# METROPOLITAN GOVERNMENT OF NASHVILLE AND DAVIDSON COUNTY

## STAFF RECOMMENDATION 2519 Blair Boulevard March 21, 2018

**Application:** New construction – addition; Partial demolition  
**District:** Hillsboro-West End Neighborhood Conservation Zoning Overlay  
**Council District:** 18  
**Map and Parcel Number:** 10415002600  
**Applicant:** Manuel Zeitlin, Architect  
**Project Lead:** Melissa Sajid, [melissa.sajid@nashville.gov](mailto:melissa.sajid@nashville.gov)

Figure 1: 2519 Blair Boulevard

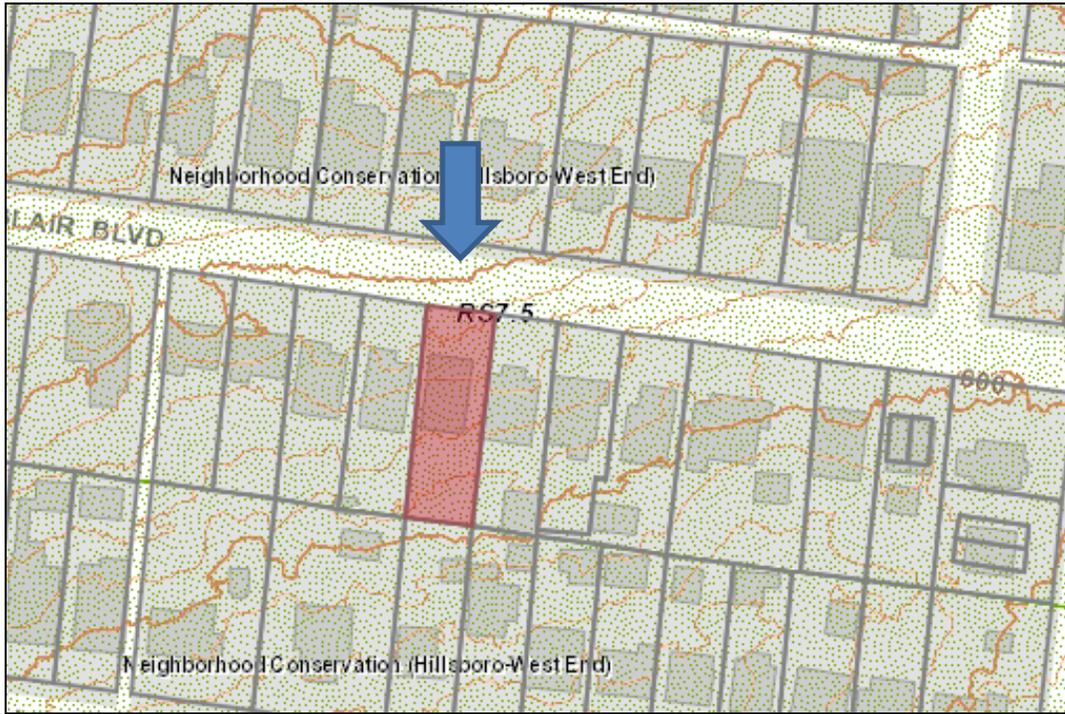
Partial demolition: The application includes replacing the center metal porch post with a new porch column and base to match the other two existing porch posts (Figure 1). Staff finds that this is appropriate as metal porch posts were not typically used during this period of construction and is likely not original to the house.

Figure 2: 1931 Sanborn map

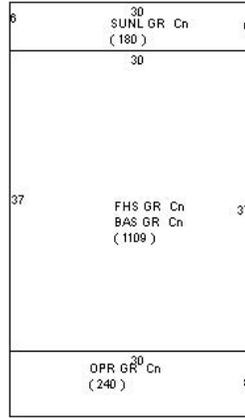
The request also includes demolishing an existing rear sunroom addition. The current building footprint on the Property Assessor’s card shows the enclosed sunroom on the rear while the sunroom is not present on the 1931 Sanborn map (Figures 2 and 3). In addition, the foundation on the addition to be demolished is concrete while the foundation of the historic house is brick, and the foundation on the addition to be demolished is at a different height than the foundation on the historic house (Figure 4). For these reasons, staff finds that the portion of the house to be demolished is non-contributing. Furthermore, staff finds that the proposed partial demolition is appropriate and meets Section III.B.2 for appropriate demolition and does not meet section III.B.1 for inappropriate demolition.

**A2**

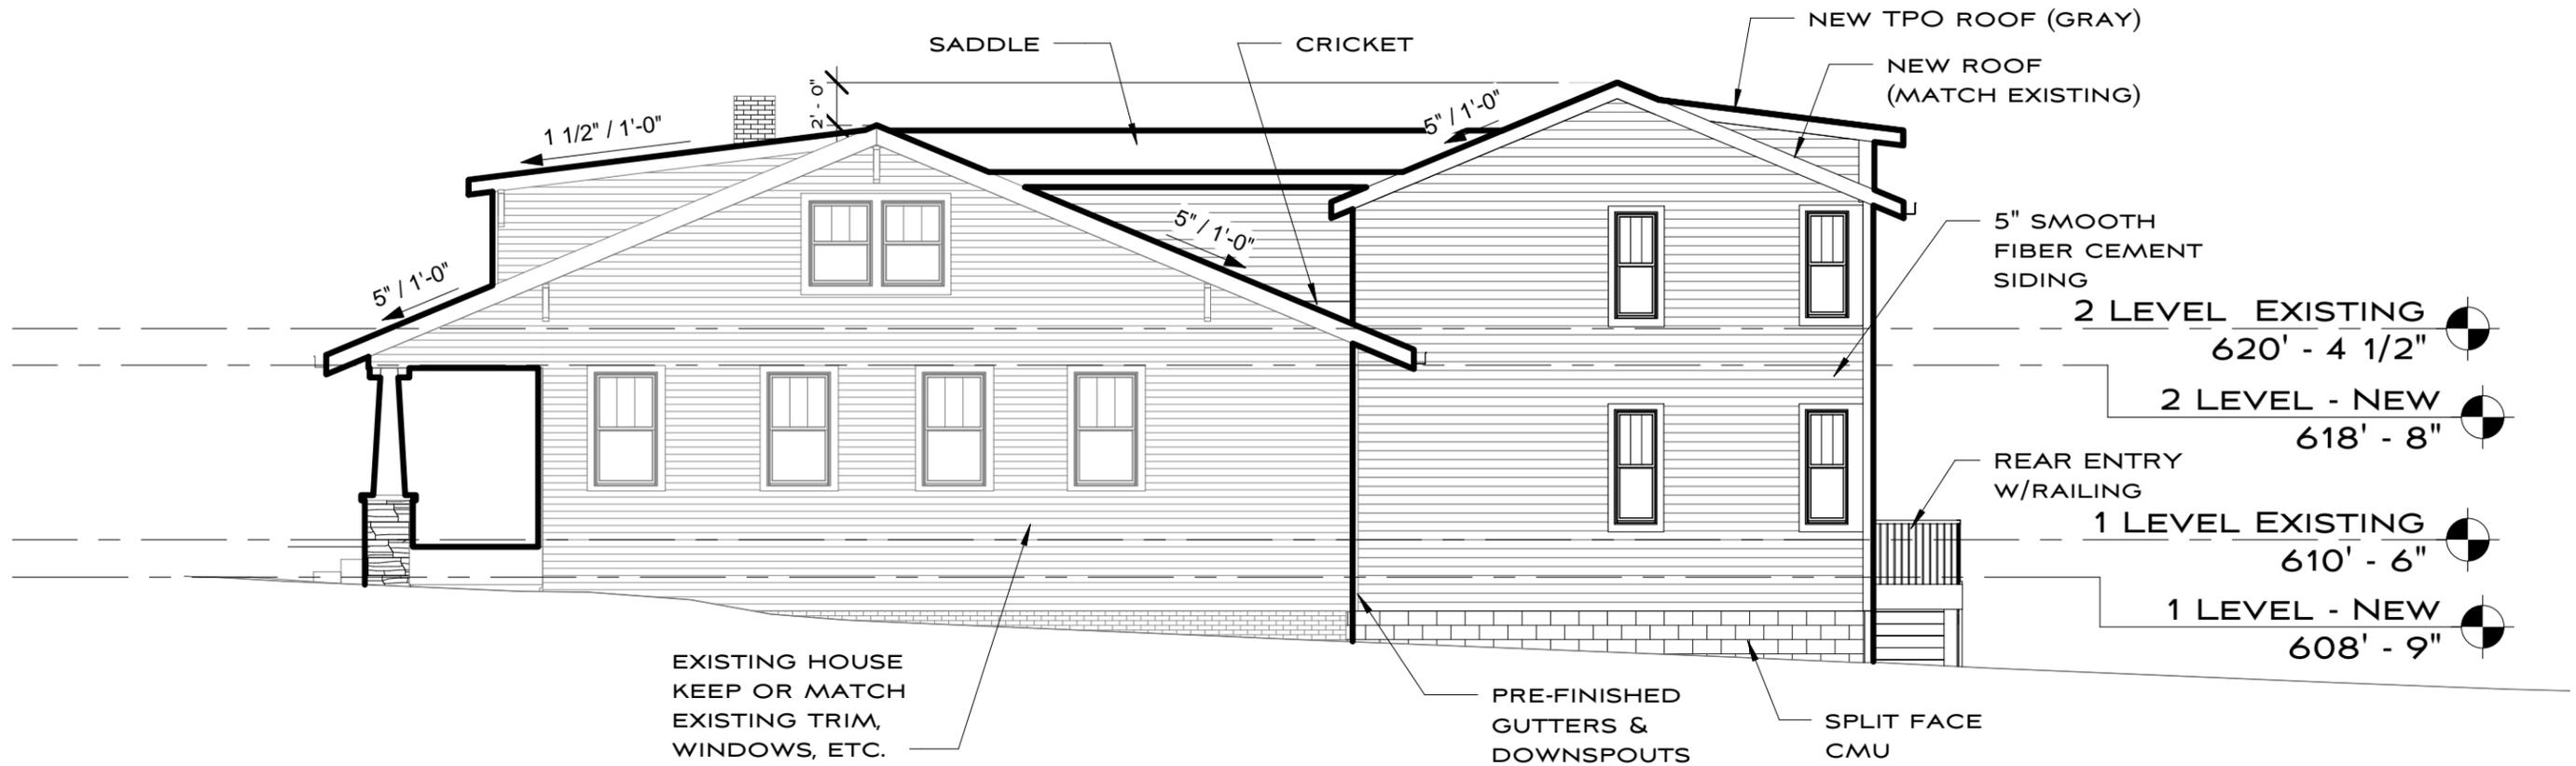
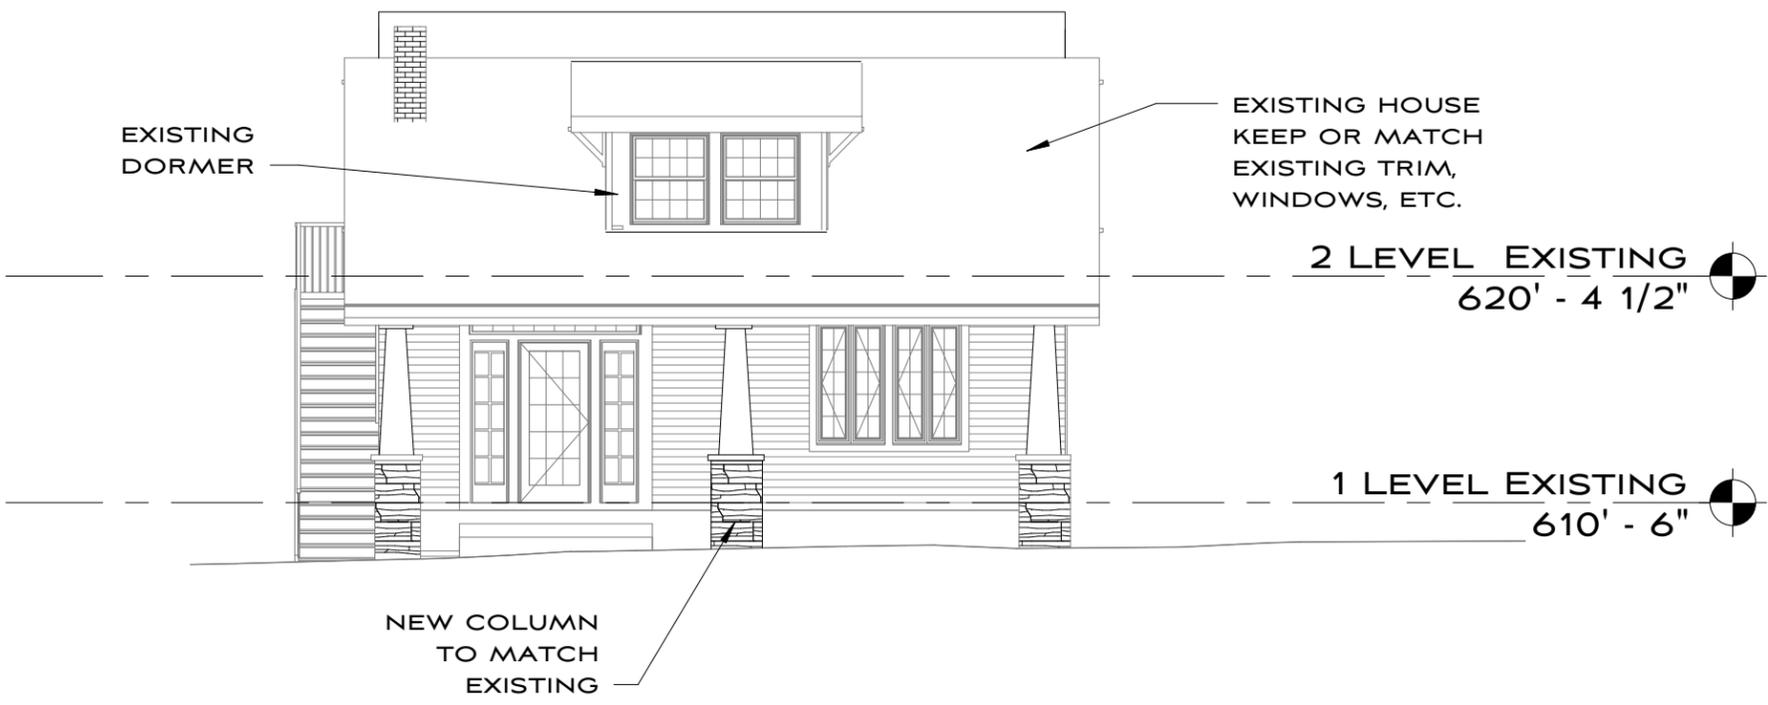
Roof form: The roof of the addition will be a side-gable that ties into the roof form of the historic house via a saddle that sits six inches (6”) below the ridge of the existing roof. The pitch of the proposed side gable is 5:12, which is the same as the existing side gable. Staff finds the roofs of the proposed addition to be compatible with the existing building and to meet section II.B.1.e of the design guidelines.

Proportion and Rhythm of Openings: The windows on the proposed addition are generally twice as tall as they are wide, thereby meeting the historic proportions of openings. There are no large expanses of wall space without a window or door opening. At this time, there is no plan to replace the existing windows and doors. Staff finds the project’s proportion and rhythm of openings to meet section II.B.1.g of the design guidelines.
